ORIGINATION FORM

Proposed Revisions to a Standard Plans Index (Please provide all information – Incomplete forms will be returned)

| Contact | Information: | Standard P | lans: | - | | | |
|--|--|-----------------------|----------------|--|---|--|--|
| Date: July | y 1, 2019 | Index Numb | er: 425 | -031 | | | |
| • | | Index Title: | Old: Sho | oulder Barrier Inlet | | | |

INDEX 425-031

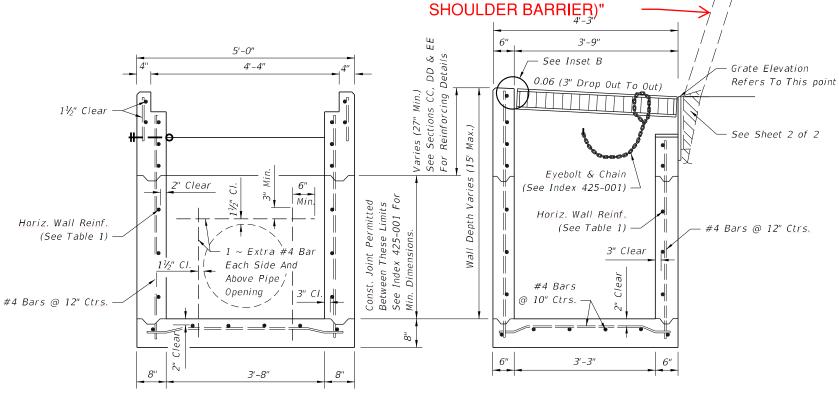
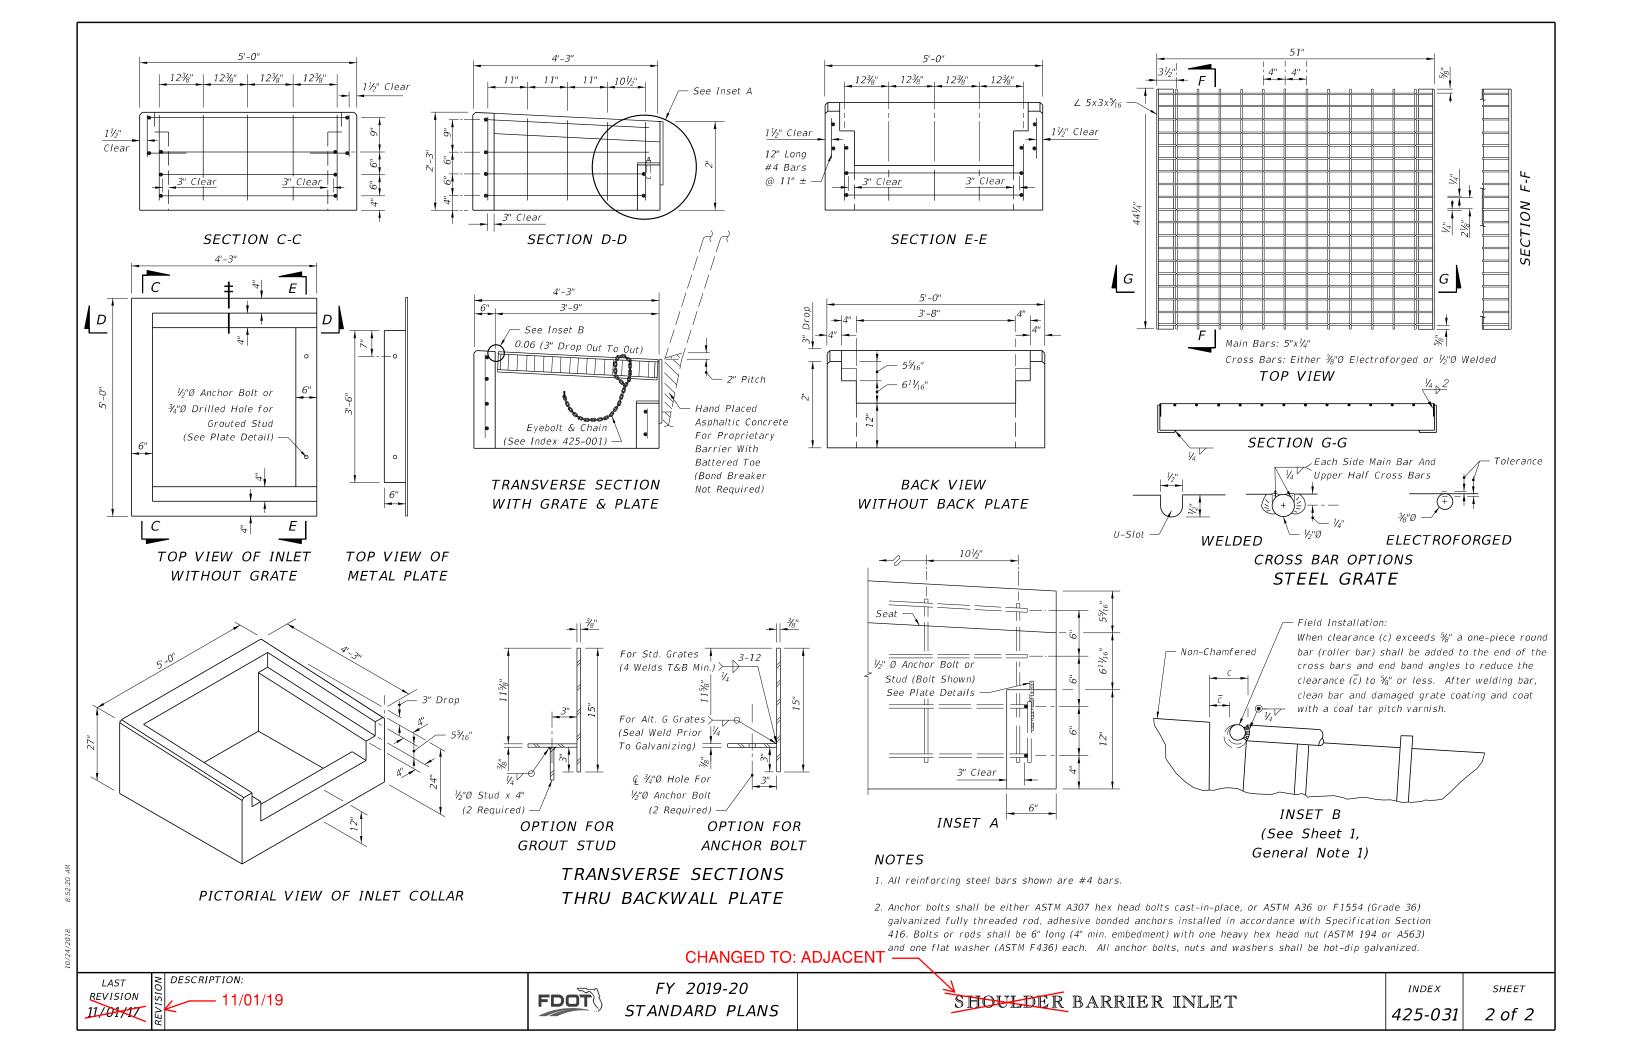
CHANGED TO " -**EXAMPLE BARRIER** TYPES" (TO NOT **EXCLUDE MEDIAN BARRIER**)

ADDED LABEL "CONCRETE

BARRIER (MEDIAN OR

CHANGED NOTE 1 TO INCLUDE OTHER Not Shown)

CHANGED TO: ADJACENT

INDEX 425-031

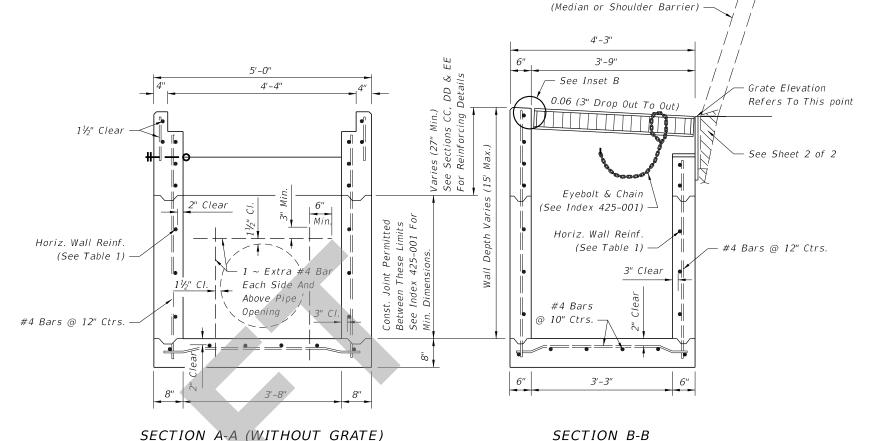
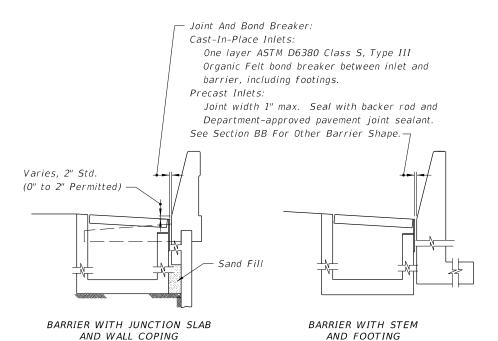
| Contact | Information: | Standard P | lans: | - | | | |
|--|--|-----------------------|----------------|--|---|--|--|
| Sheet 1: | Changed GENERAL NOTE 1 to include median | barriers. Upd | lated sec | ction labels to include median barriers. | | | |

- 1. Where called for in the Plans, use this inlet in conjunction with median or shoulder barrier per Index 521-001 or a barrier with junction slab and wall coping per Index 521-610. The inlet is suitable for bicycle and occasional pedestrian traffic, with roller bar installation (see INSET B), but should not be placed in a designated pedestrian travel way.
